Report pursuant to s42A Resource Management Act 1991

In the matter of:	A Notice of Requirement to construct and operate a new intermodal rail and freight hub on land between Palmerston North and Bunnythorpe
And:	A hearing by Palmerston North City Council pursuant to s100A
Requiring Authority:	KiwiRail Holdings Ltd
Hearing date:	9 August 2021

S42A Technical Evidence: Traffic and Transportation

By: Harriet Fraser

Figure 11: NEIZ Structure Plan Map

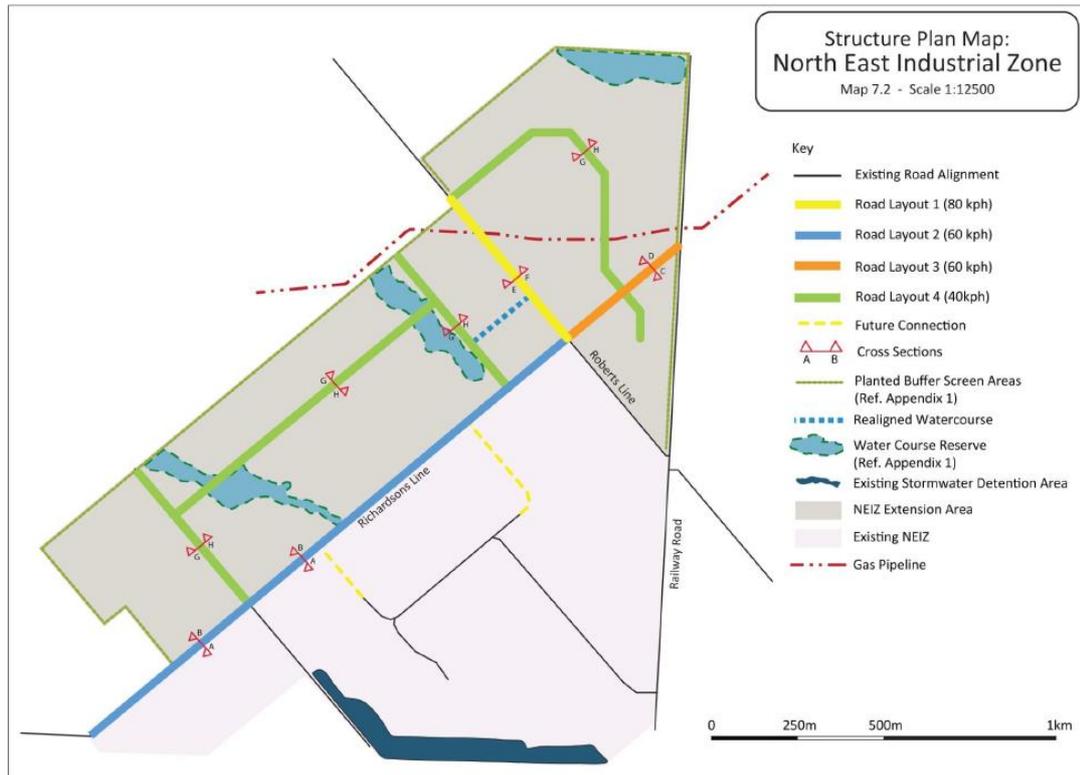
96. A copy of the NEIZ Structure Plan is included below as Figure 11. The desired future rooding links within the NEIZ are shown. Richardsons Line (blue line on map) and Setters Line (southernmost green line on map) are programmed to be upgraded. At this stage, there are no plans for the delivery of the other green roads or the roads shown as yellow dotted lines. These improvements would be triggered by resource consent applications and would be subject to discussions between the applicant and Council. There are no designations in place to secure the delivery of this infrastructure, located within private land.

97. No upgrades are included for the El Prado Drive intersection with Railway Road in the 10 Year Plan. The need for any upgrade will depend on the rate of development of the NEIZ, increases in traffic flows along Railway Road and whether road connections can be achieved through to Richardsons Line as indicated by the broken yellow lines on the Structure Plan.
